Contract #: 04-0120F4Cty: SF/ALA Rte: 80 PM: 13.2/13.9File #: 69.25B**QUALITY ASSURANCE -- NON-CONFORMANCE REPORT****Location:** Changxing Island, Shanghai, China**Report No:** NCR-000771**Prime Contractor:** American Bridge/Fluor Enterprises, a JV**Date:** 21-Jun-2010**Submitting Contractor:** Zhenhua Port Machinery Company, Ltd (ZPMC), Changxing Island**NCR #:** ZPMC-0733**Type of problem:**

**Reference Description:** Weld Removal on SPCM Welds without Engineer's Approval**Description of Non-Conformance:**

**Subject:** NCR No. ZPMC-0733

Contract #: 04-0120F4Cty: SF/ALA Rte: 80 PM: 13.2/13.9File #: xx.25A**QUALITY ASSURANCE -- NON-CONFORMANCE RESOLUTION****Location:** Changxing Island, Shanghai, China**Report No:** NCS-000729**Prime Contractor:** American Bridge/Fluor Enterprises, a JV**Date:** 23-Aug-2010**Submitting Contractor:** Zhenhua Port Machinery Company, Ltd (ZPMC), Changxing Island **NCR #:** ZPMC-0733**Type of problem:**

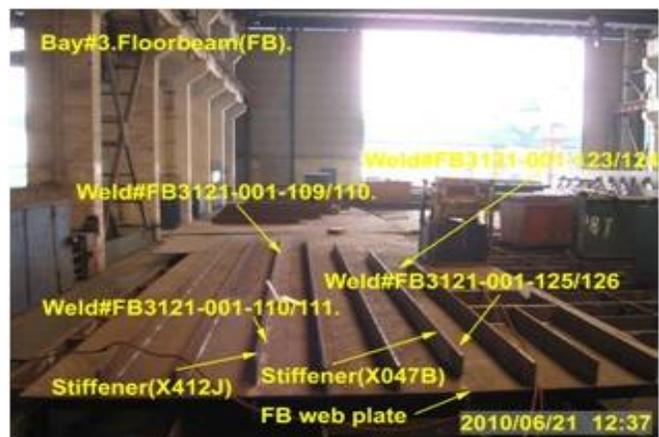
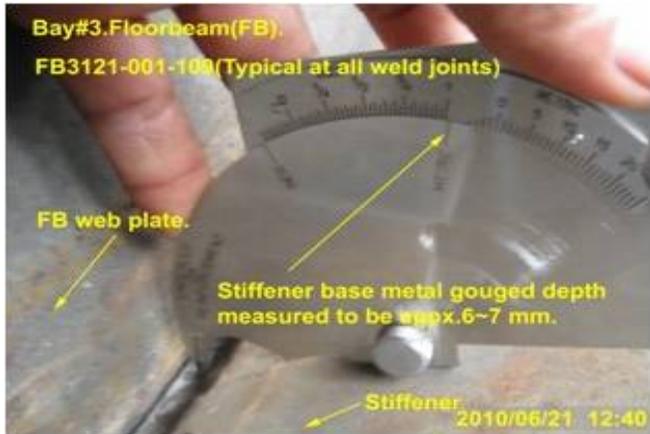
- ZPMC removed Seismic Performance Critical Material (SPCM) welds without Engineers approval as required per American Weld Society (AWS) D1.5 2002 section 12.17.3.

- The weld joints are identified as FB3121-001-108, 109, 123 and 124.
- The welds are fillet weld T-joints joining 2 of the stiffeners to the SPCM areas of floor beam FB3121A.

- SPCM web plates are identified as X3406A and X3405A.
- The stiffeners are identified as X3412J and X7047B.
- Additionally this QA Inspector observed ZPMC has refit the two stiffeners and commenced re-welding them to the web plates of this floor beam without properly preparing the weld joints.

- Base metal that was removed from the edges of the stiffeners during the gouging operation has not been repaired and cleaned prior to re-fitting and welding.

- This QA measured the depth of the gouged areas of the edges of the stiffeners to be approximately 6mm.
- OBG FB3121-001 is located in Bay#3.

For further information, please reference the attached pictures.

ZPMC is providing NDT records show the base metal was repaired and was tested to be acceptable. The welding for ribs on this panel has been finished and passed the NDT as shown in attached NDT records. ZPMC QA personnel have instructed the production on the requirement to get the approval of engineer prior to the removal of FCW. Based on this, ZPMC is requesting closure of this NCR.

Contractor submitted post repair NDT verifying base metal repairs and replacement welds meet Contract weld quality requirements.

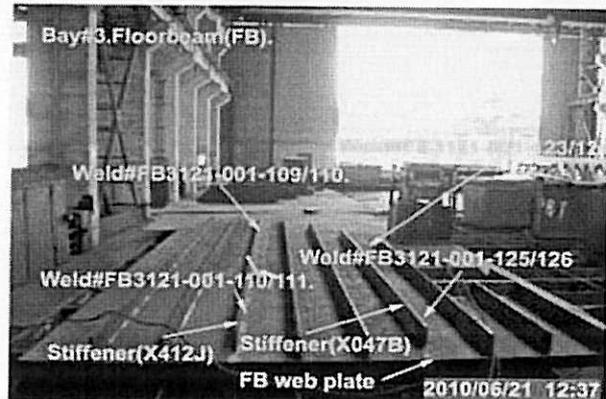
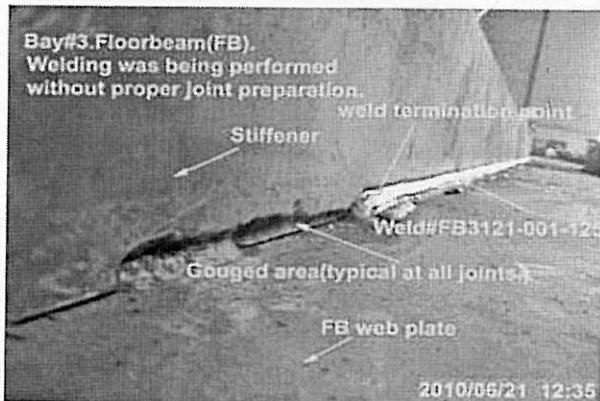
- ZPMC removed Seismic Performance Critical Material (SPCM) welds without Engineers approval as required per American Weld Society (AWS) D1.5 2002 section 12.17.3.

- The weld joints are identified as FB3121-001-108, 109, 123 and 124.
- The welds are fillet weld T-joints joining 2 of the stiffeners to the SPCM areas of floor beam FB3121A.

- SPCM web plates are identified as X3406A and X3405A.
- The stiffeners are identified as X3412J and X7047B.
- Additionally this QA Inspector observed ZPMC has refit the two stiffeners and commenced re-welding them to the web plates of this floor beam without properly preparing the weld joints.

- Base metal that was removed from the edges of the stiffeners during the gouging operation has not been repaired and cleaned prior to re-fitting and welding.

- This QA measured the depth of the gouged areas of the edges of the stiffeners to be approximately 6mm.
- OBG FB3121-001 is located in Bay#3.

For further information, please reference the attached pictures.

Perform repairs and subsequent NDT required to verify material quality.
